# IN THE UNITED STATES PATENT AND TRADEMARK OFFICE

: BANKNOTE VALIDATOR

: INN 0004 NA

# PRELIMINARY AMENDMENT

FIG. 10

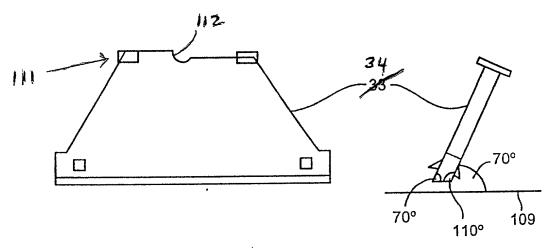
Applicants also submit herewith proposed corrections to Figs. 10 and 12 which correctly refer to the light guide 34. In addition, Fig. 10 has additionally been corrected to include reference numerals 111 and 112, which are identified in the specification at page 14, lines 14-16.

Referring to Figure 10, the broad ends of the light guides [33] 34, 104 make angles of 70° and 110° respectively to the front and rear faces of the light guides [33] 34, 104. Consequently, light guided by the light guides [33] 34, 104 is not perpendicularly incident on a banknote 109 in the banknote path 6. The narrow ends 111 of the light guides [33] 34, 104 have semi-circular cut-outs 112 which serve to spread light being shone therein.

Referring to Figure 10, the broad ends of the light guides 34, 104 make angles of 70° and 110° respectively to the front and rear faces of the light guides 34, 104. Consequently, light guided by the light guides 34, 104 is not perpendicularly incident on a banknote 109 in the banknote path 6. The narrow ends 111 of the light guides 34, 104 have semi-circular cut-outs 112 which serve to spread light being shone therein.
